UNITED STATES PATENT AND TRADEMARK OFFICE

APPLICATION NO.	FILING DATE	FIRST NAMED INVENTOR	ATTORNEY DOCKET NO.	CONFIRMATION NO.
10/729,679	12/05/2003	Kenneth M. Sprouse	7784-000644	3173
27572	7590	02/02/2006	EXAMINER	
HARNESSE, DICKEY & PIERCE, P.L.C.			KOCZO JR, MICHAEL	
P.O. BOX 828			ART UNIT	PAPER NUMBER
BLOOMFIELD HILLS, MI 48303			3746

Office Action Summary	Application No. 10/729,679	Applicant(s) SPOUSE ET AL	
	Examiner Michael Kocz, Jr.	Art Unit 3746

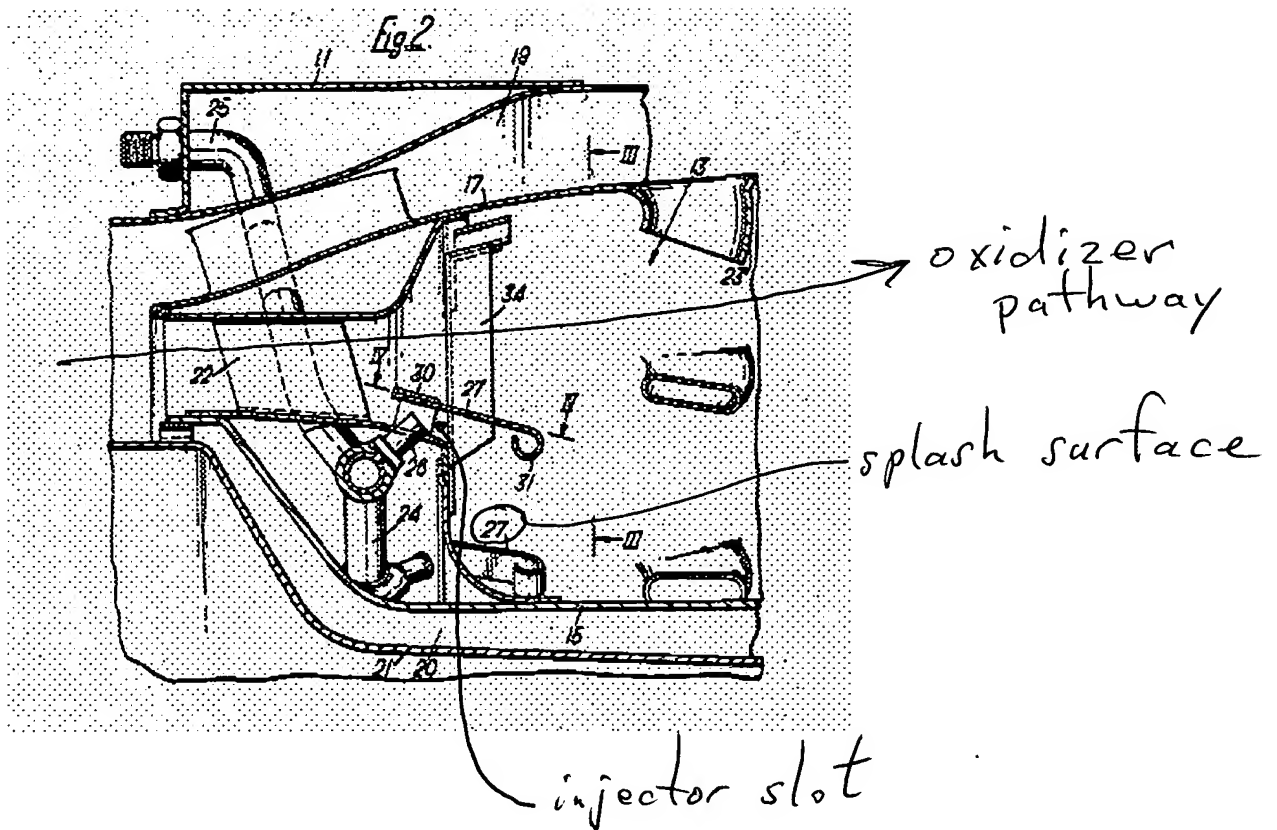
Claims 12, 13, 15, 16, 17, 22, 23, 24 and 25 are rejected under 35 U.S.C. 103(a) as being unpatentable over Carlisle in view of Amann. Carlisle discloses the invention substantially as claimed. However, Carlisle does not disclose a preheat section to heat the oxidizer. Amann discloses that it is known to use a regenerator 7 to preheat the oxidizer in order to recover energy which would otherwise be wasted. In view of this teaching, it would have been obvious to

provide the gas turbine of Carlisle with a recuperator for heating the oxidizer. Figure 2 of Carlisle is reproduced below with the relevant portions labeled with the corresponding claim elements. Regarding claims 12 and 22, the “wherein” clauses merely recite a desired result. Whether or not the fuel substantially mixes with the oxidizer from the oxidizer pathway prior to combusting is dependent on operating parameters, such as the flow rates, pressures and temperatures of the fuel and air, which are beyond the scope of the claims. The structure of Carlisle is furthermore inherently capable of mixing the fuel with the stream of oxidizer before any portion of the fuel combusts given the right operating parameters. Regarding claims 23 to 25, these claims merely recite the intended use of the injector and do not define structurally over the injector of Carlisle. The injector of Carlisle is inherently capable of injecting the different fuels as recited in claim 25.

Applicant argues that Carlisle does not teach an injector slot near an oxidizer pathway. Referring to figure 2 of Carlisle, the injector slot is adjacent the oxidizer pathway. This is readable as an injector slot near the oxidizer pathway.

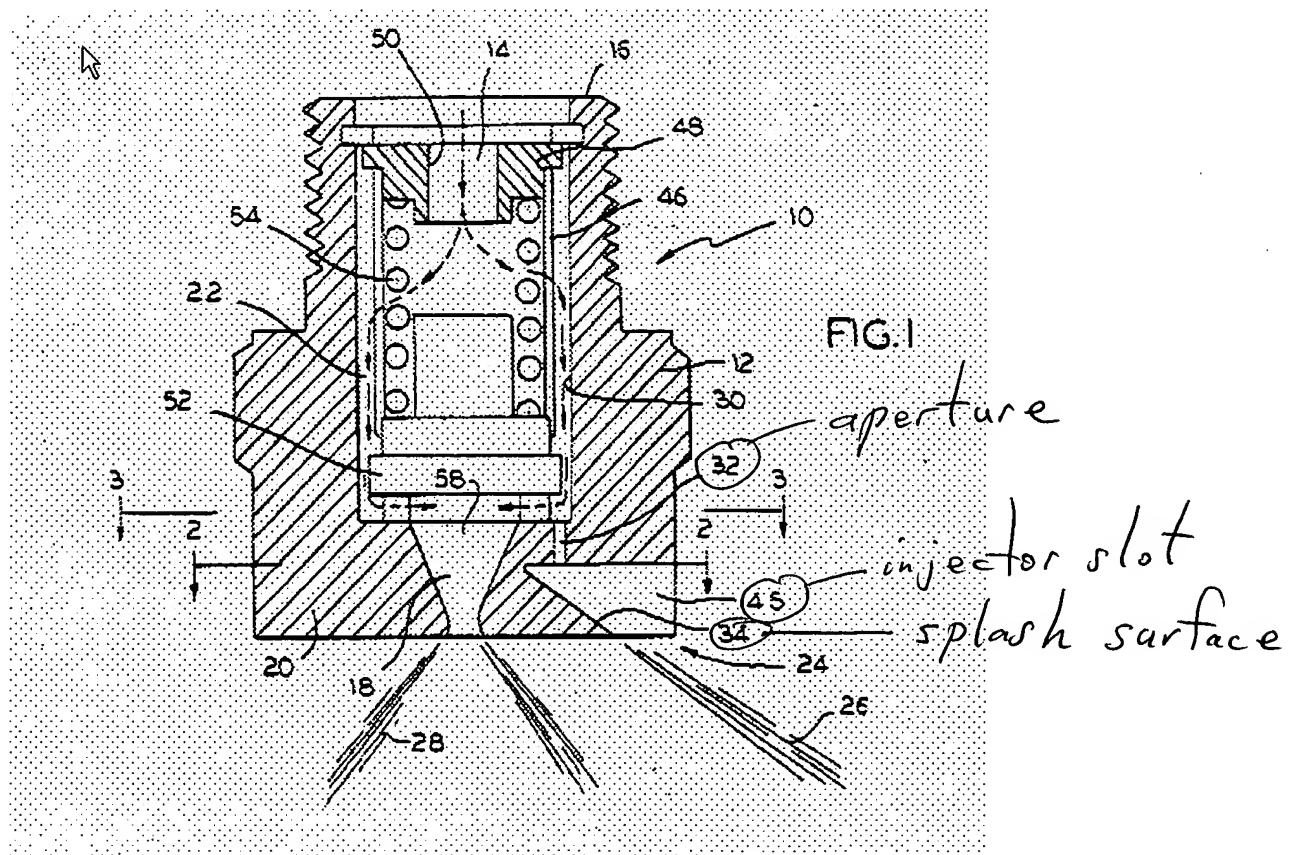
Claims 12, 13, 15, 16, 17, 22, 23, 24 and 25 are also rejected under 35 U.S.C. 103(a) as being unpatentable over Shekelton et al. in view of Amann. Shekelton et al. disclose the invention substantially as claimed. However, Shekelton et al. do not disclose a preheat section to heat the oxidizer. Amann discloses that it is known to use a regenerator 7 to preheat the oxidizer in order to recover energy which would otherwise be wasted. In view of this teaching, it would have been obvious to provide the gas turbine of Shekelton et al. with a recuperator for heating the oxidizer. Figure 1 of Shekelton et al. is reproduced below with the relevant portions labeled with the corresponding claim elements. Regarding claims 12 and 22, the “wherein” clauses merely recite a desired result. Whether or not the fuel substantially mixes with the oxidizer from

the oxidizer pathway prior to combustng is dependent on operating parameters, such as the flow rates, pressures and temperatures of the fuel and air, which are beyond the scope of the claims.

Shekelton et al. The injector of Shekelton et al. is inherently capable of injecting different fuels.

Applicant argues that Shekelton et al do not teach an injector slot near an oxidizer pathway. Any flow of oxidizer is readable as an oxidizer pathway. Referring to figures 1 and 4 of Shekelton et al, it can be seen that the oxidizer flows adjacent the injector nozzles. That is, the injector slot 45 is near the oxidizer pathway.
